8. Kinder Subdivision Blake Addition No. 1 KPB File 2023-127 Segesser Surveys / The Homestead, LLC Location: Cohoe Loop Road

Kinder Subdivision Blake Addition No. 1

ITEM #8 - PRELIMINARY PLAT Kinder Subdivision Blake Addition No. 1

STAFF REPORT

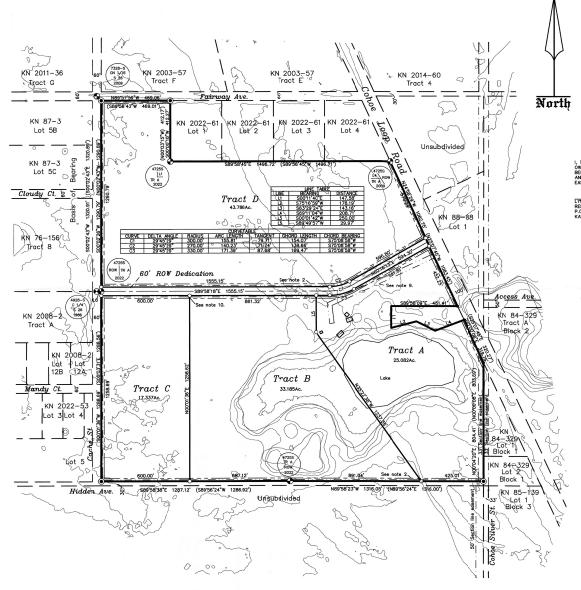
There are no steep areas or drain ways, on the plat. Contours can be removed from the final.

There is an unnamed lake located on the plat that has an area of inundation located to the west of it. There area of inundation is shown, but should be expanded to match KPB imagery showing wetland area to the east and south of what is currently shown on the drawing. Wetlands should be shown on the final along with the lake. **Staff recommendation**: place a note on the final plat indicating any person developing the property is responsible for obtaining all required local, state, and federal permits, including a U.S. Army Corps of Engineers wetland determination if applicable.

10- foot utility easements are proposed along the rights-of-ways. **Staff recommendations:** add more labels of the "See note 10" to the drawing. Adjust the note in the northwest corner of Tract B as the identifier is confusing with its pointer and the pin mark and lot line.

There are electric easements identified on the drawing and listed in the notes from the certificate to plat. **Staff recommendations:** the point for See note 9 in Tract A1 needs moved as it is confusing in its positioning. HEA has given notice this easement can be reduced to 15 feet.

Add to the KBP No. 2023-127 Adjust plat note numbering.

Add 'Unnamed' to the lake inside the property,

Add more "See note 2" to the drawing.

Add a distance across the front of the deeded tract.

Add to the legend line for the 20' setback, utility easements, area of inundation

Show and label Rilinda Road to the east including right-of-way.

Label Shiak Street to the east including right-of-way.

Label the right of way of Hidden Avenue to the west.

Lots near Rilinda Road need labeled.

Low wet areas shown, but there appears to be more to the south of what is shown that need to be added per KPB Data.

In the line table, L1 – L4 should have both measured and recorded data.
